PEER REVIEW - PRE PLANNING PROPOSAL AND URBAN DESIGN STUDY FOR THE SITE LOCATED AT 896-898 WOODVILLE ROAD AND 15 HILWA STREET

- 1.1 This planning and urban design review relates to the preliminary Planning Proposal (DPMS October 2022) and Revised Urban Design Report (Tony Owens Partners Version C - October 2022) prepared on behalf of ABA Square Pty Ltd (the Applicant).

Figure 2 Site in relation to the UDS Structure Plan

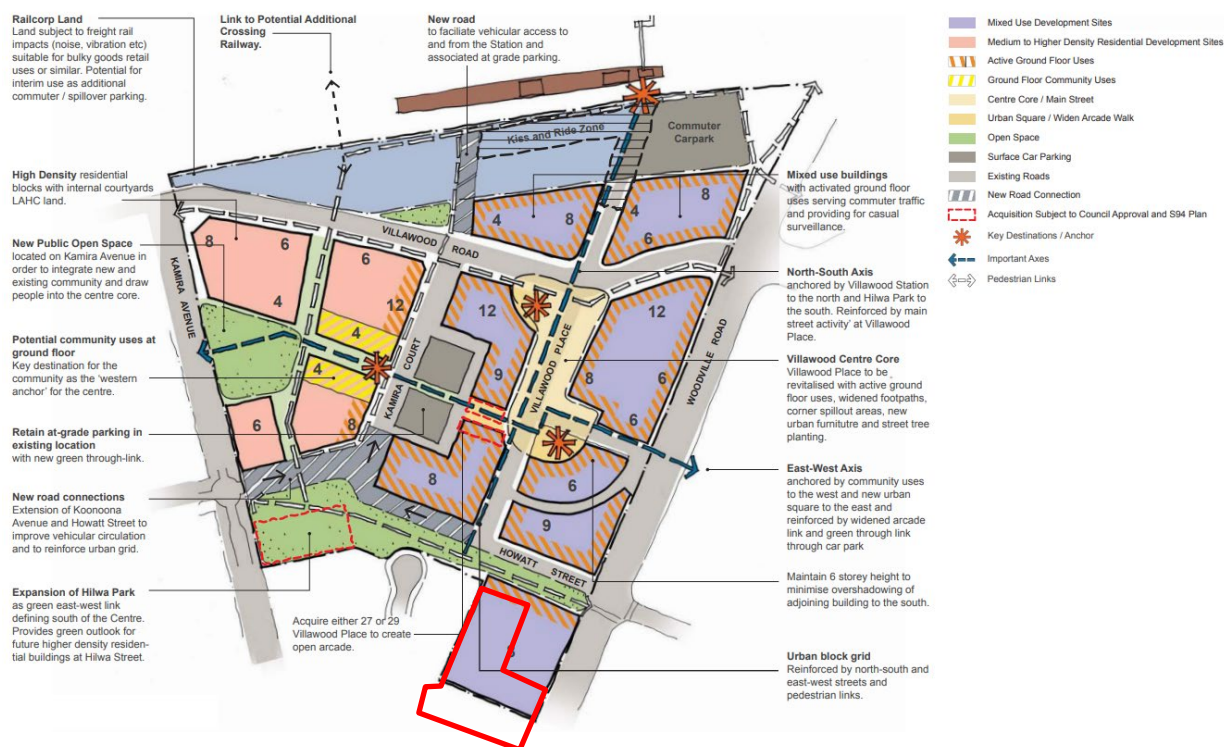
- 4.1 The site is a key opportunity site identified in the UDS located within the Villawood Town Centre - Business Precinct. The approximate location of the site in relation to the Villawood Town Centre Structure Plan is illustrated in Figure 2. Note that 15 Hilwa Street and 898 Woodville Road are outside the UDS boundary.

4.2 For this group of sites, the UDS envisages a development that:

- 4.2.1 establishes a new green link along Howatt Street, which has now been zoned RE1 Public Recreation; and
- 4.2.2 provides an active frontage to Howatt Street green link to the north, and Woodville Road to the east.

- 4.3 The consolidation of the two sites at 896 and 896A Woodville Road was considered to be critical in achieving a coordinated development outcome as intended by the UDS. Noting that the UDS did not include the additional sites 15 Hilwa Street and 898 Woodville Road.
